## ADDENDUM NO. 2

**PROJECT NAME:** Wick Alumni Center Life Safety & HVAC Improvements  
**UNL PROJECT NUMBER:** C120P021  
**BID INVITATION NUMBER:** 2222-13-7200

**CONSULTANT:** Farris Engineering  
**ADDRESS:** 818 P Street, Suite 100

**DATE OF ISSUANCE:** September 11, 2013  
**DATE OF BID OPENING:** September 18, 2013

SHEET NO  
**MD1-1**

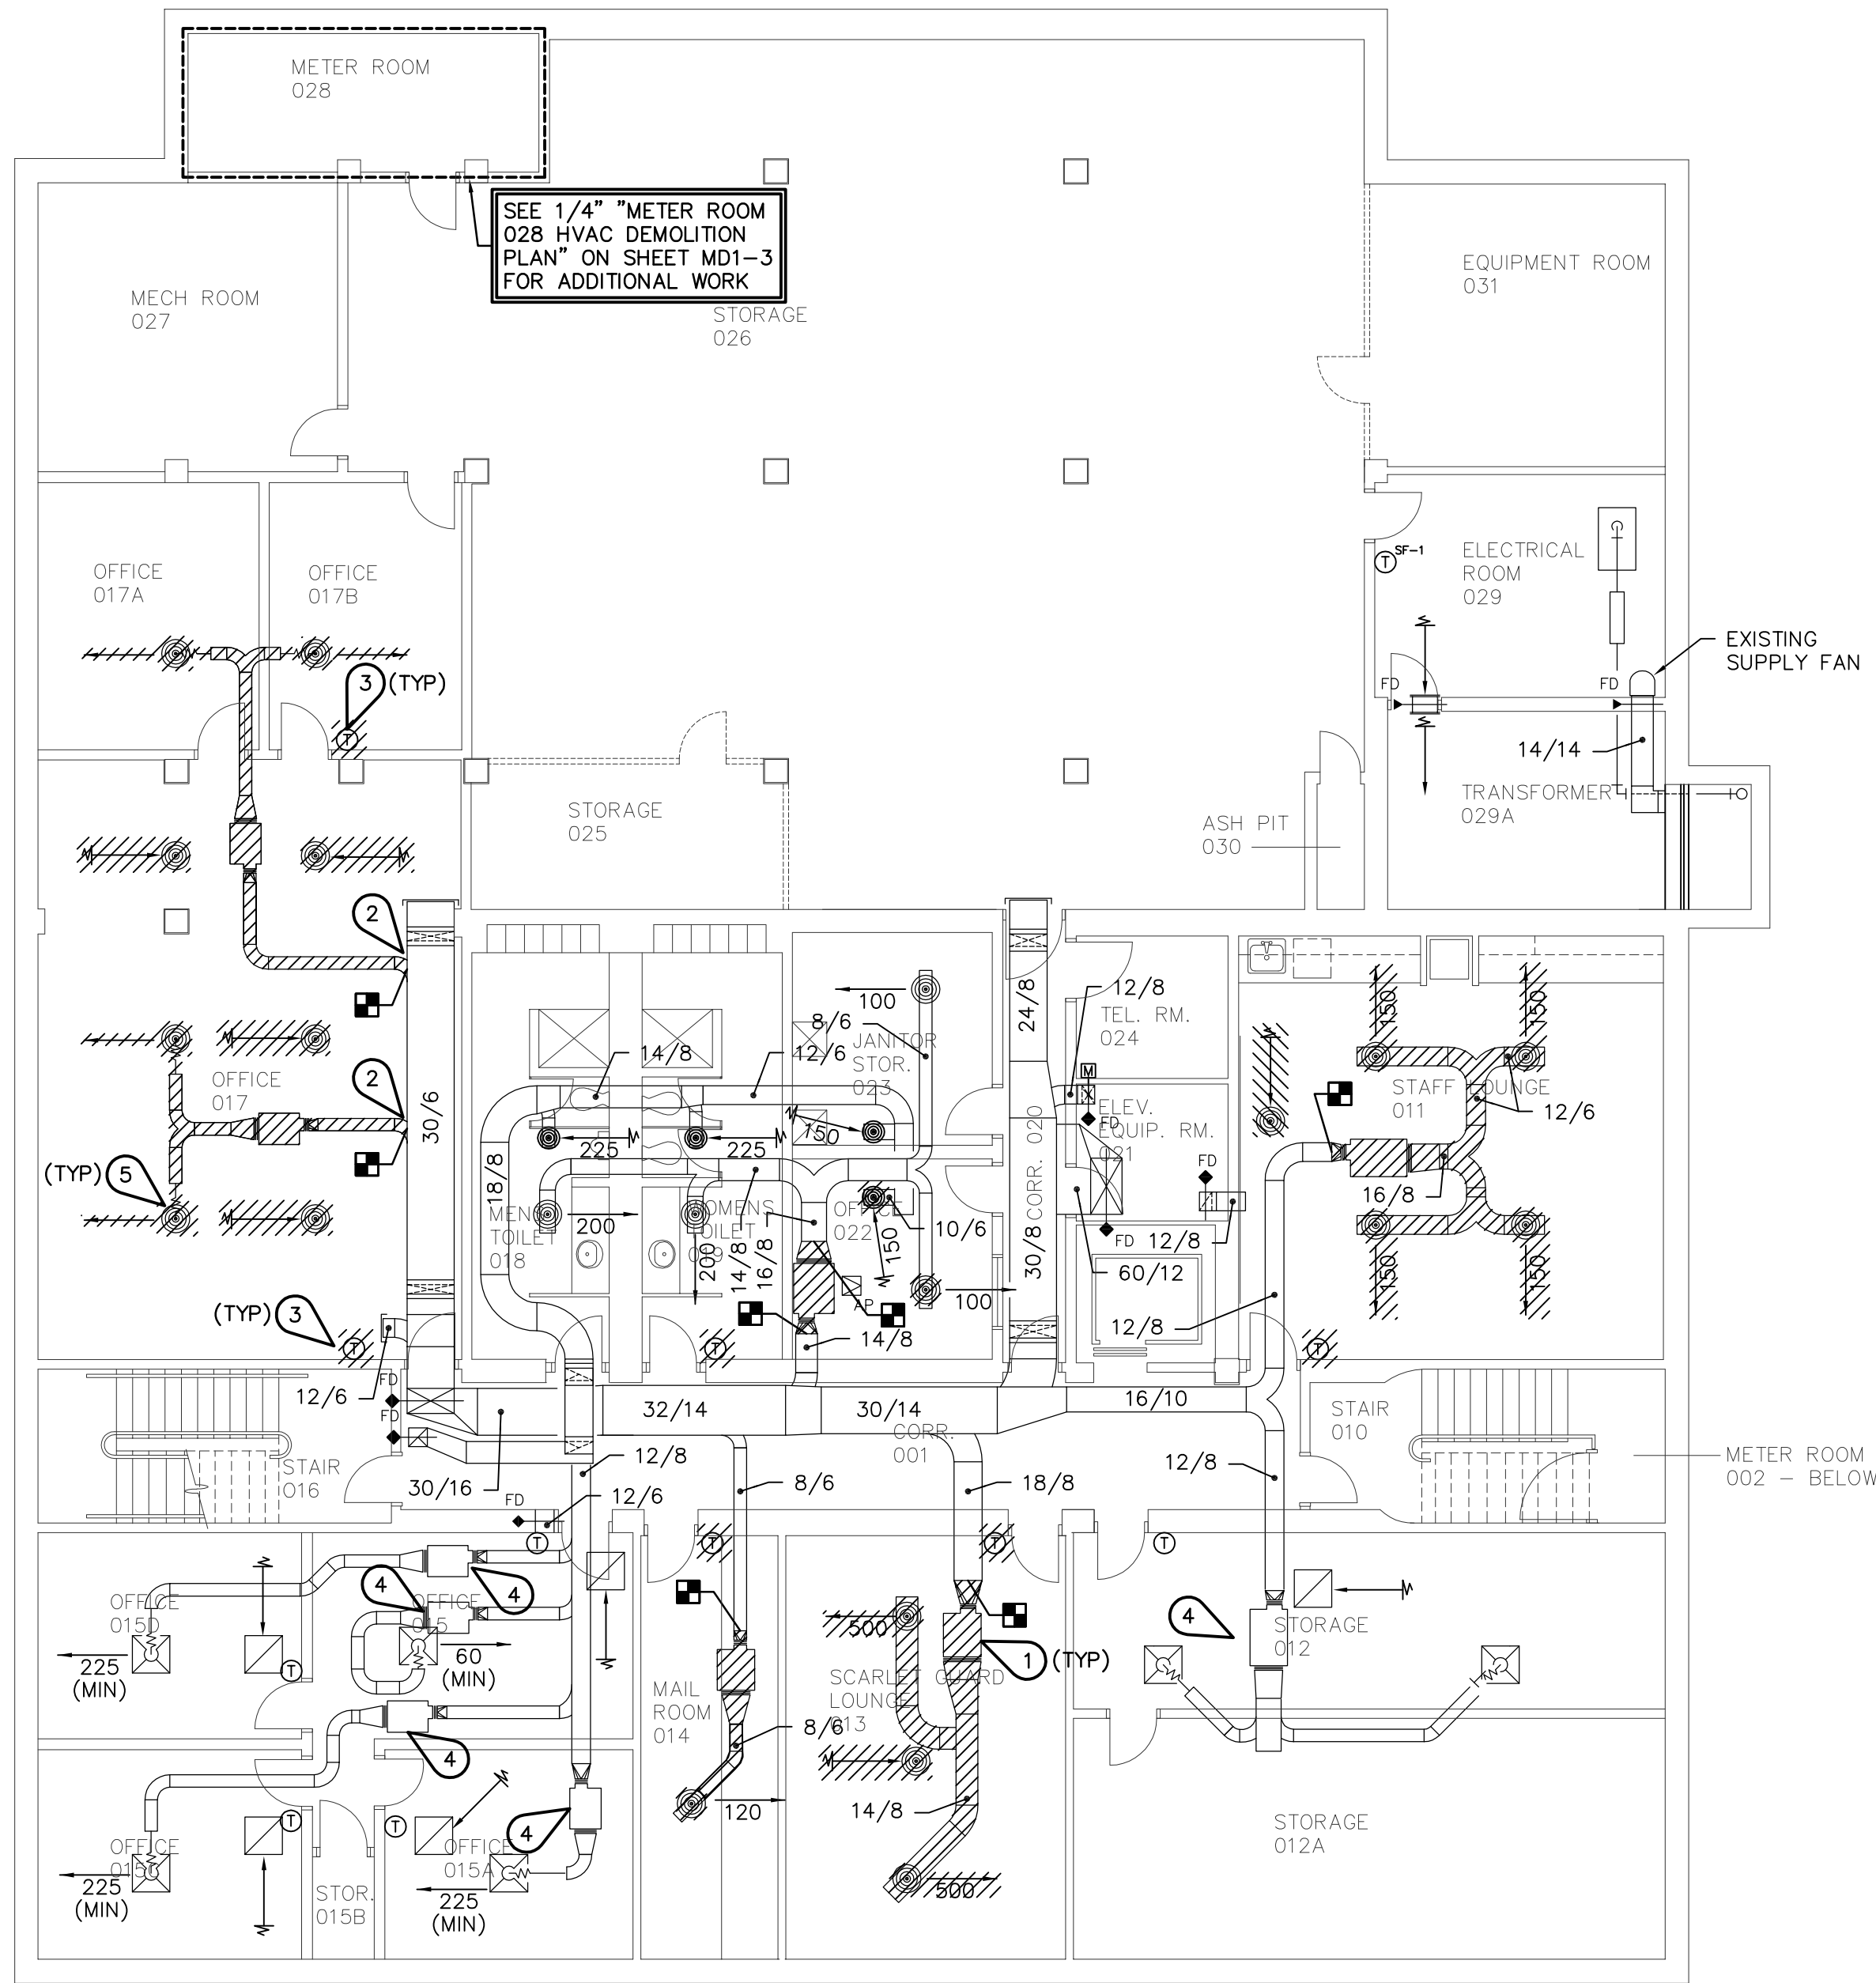
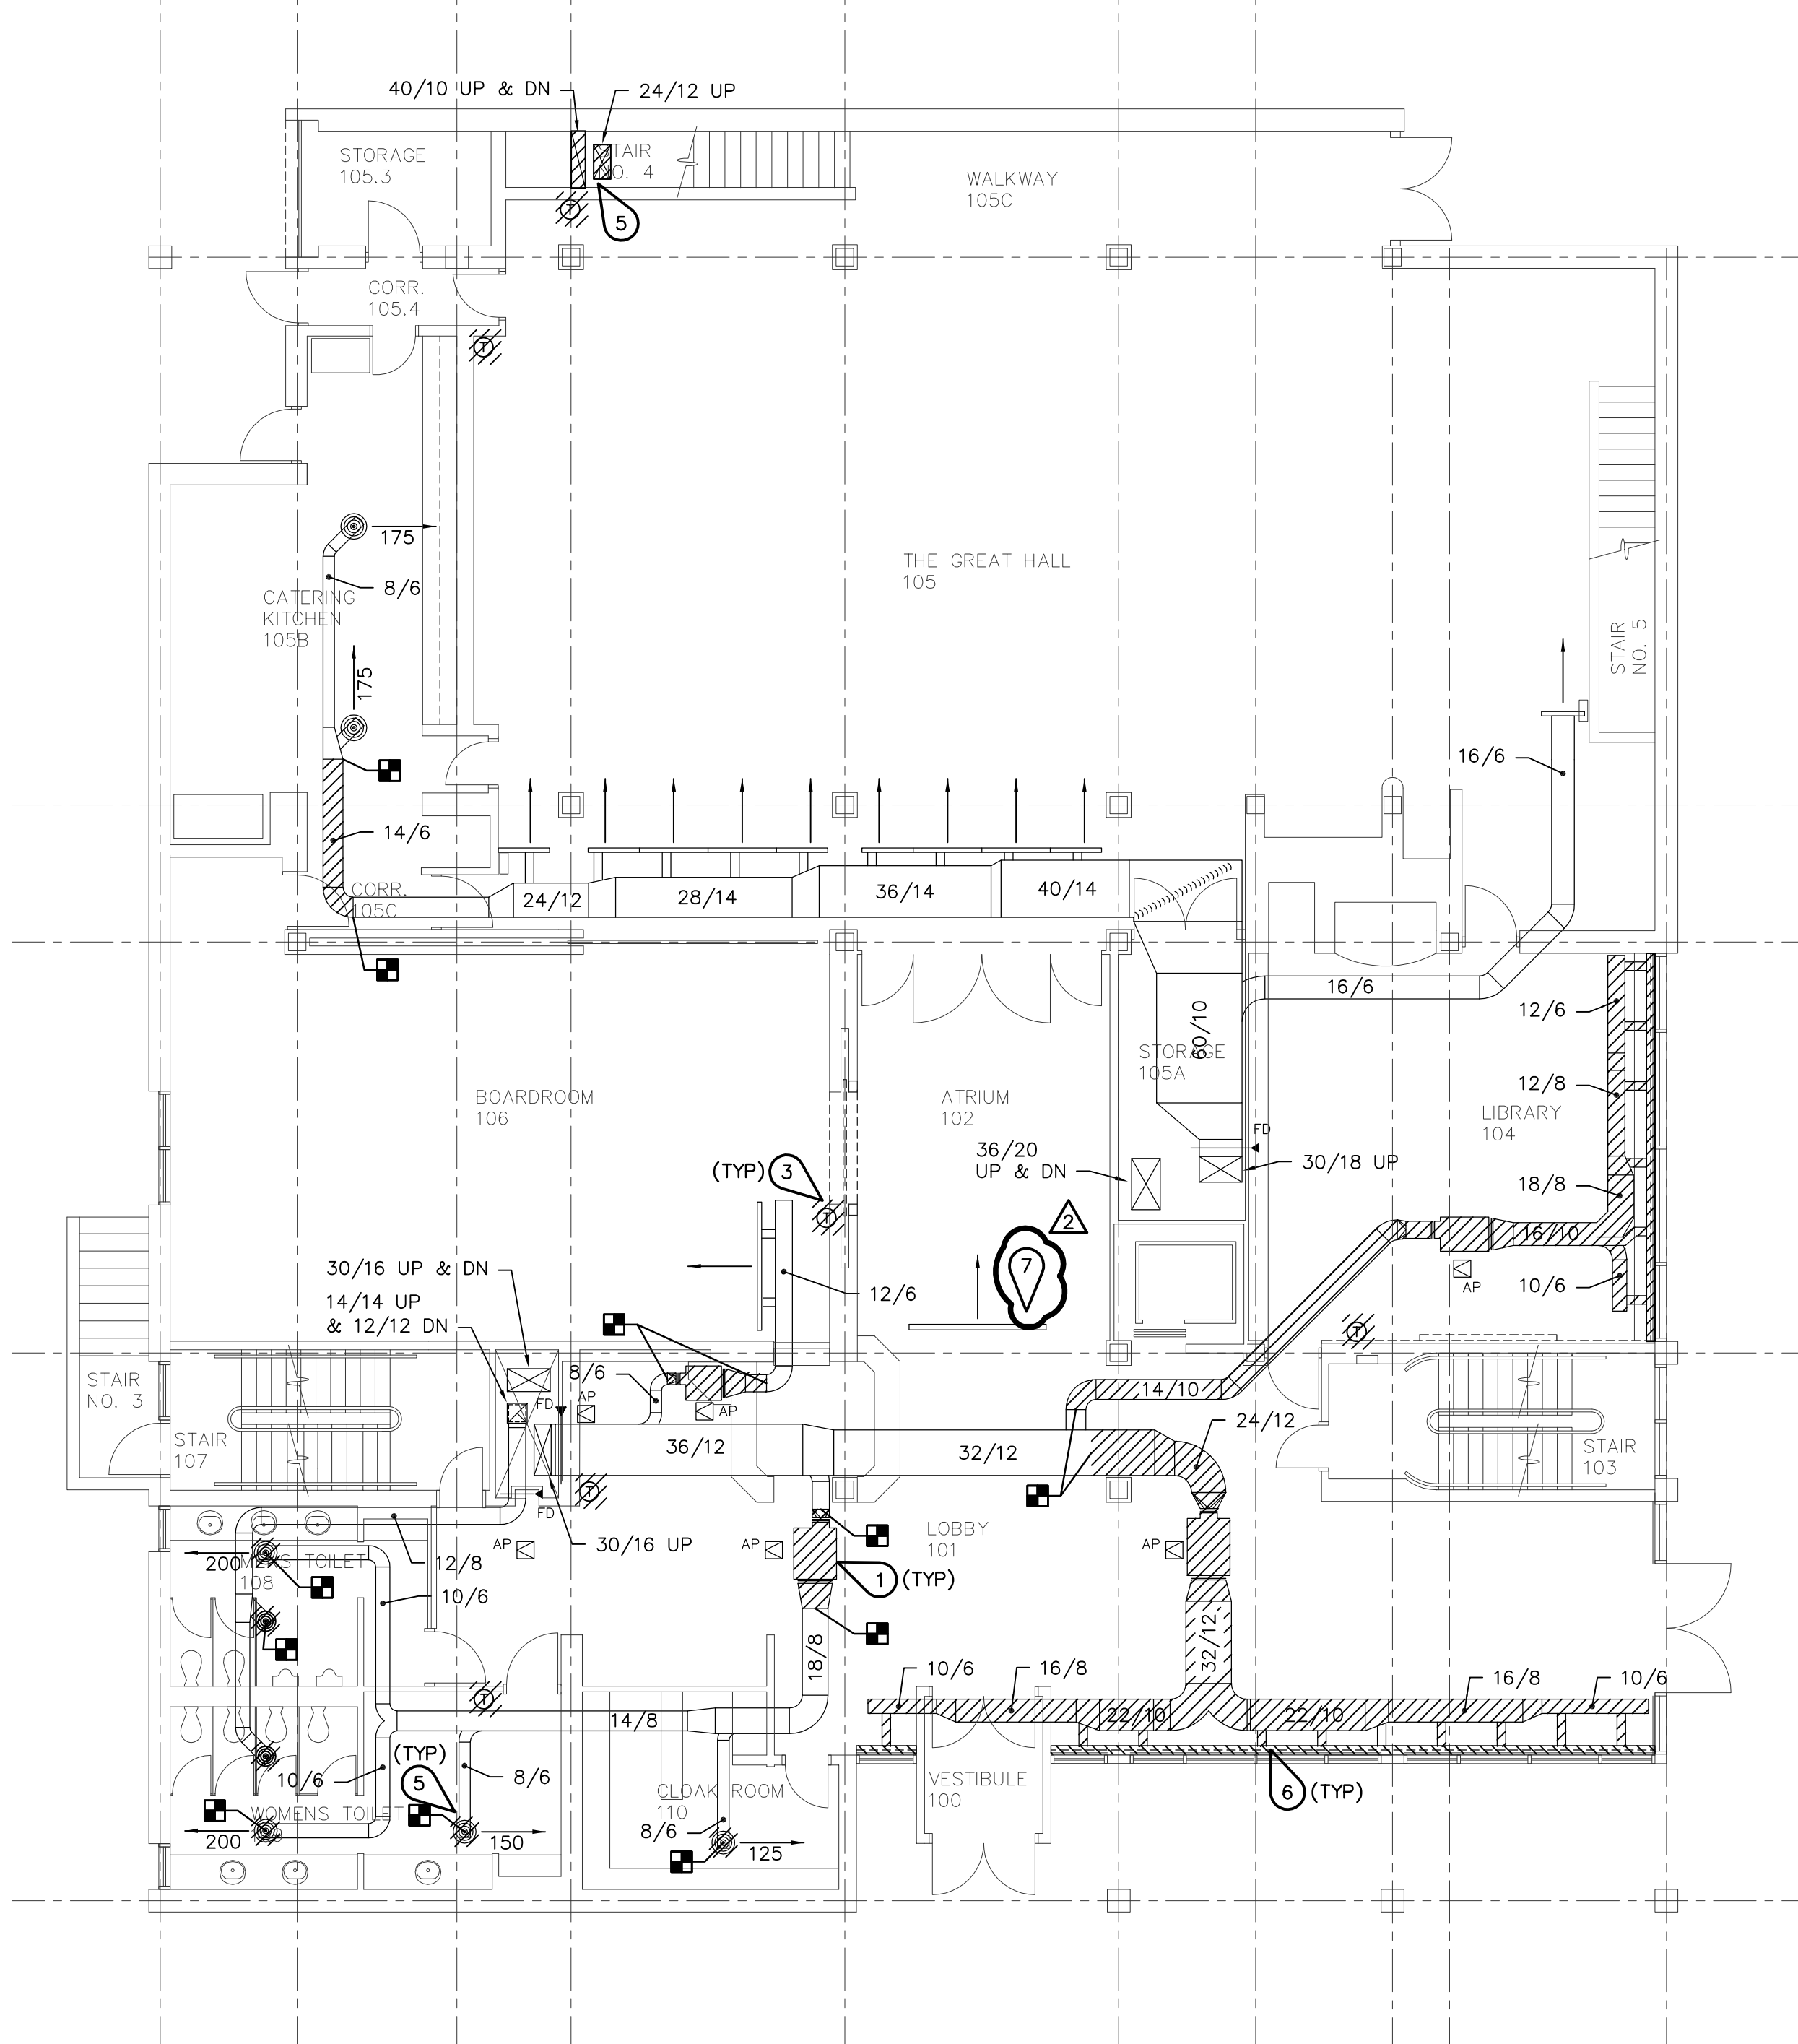
1. This sheet has been reissued in its entirety as a part of Addendum No.2.
2. Mechanical Keynote #7 has been added.

- 6 RELOCATE EXISTING 10/6 TRANSFER DUCT TO LOCATION SHOWN ON SHEET M1-2.
- 7 REMOVE EXISTING SINK AND PLUMBING AS REQUIRED. RE-INSTALL SINK IN RELOCATED CASEWORK AND RE-PLUMB AS REQUIRED. PROVIDE NEW SHUT-OFF VALVES ON HW AND CW LINES. SEE SHEET A1-2 FOR LOCATION OF RELOCATED SINK AND CASEWORK.
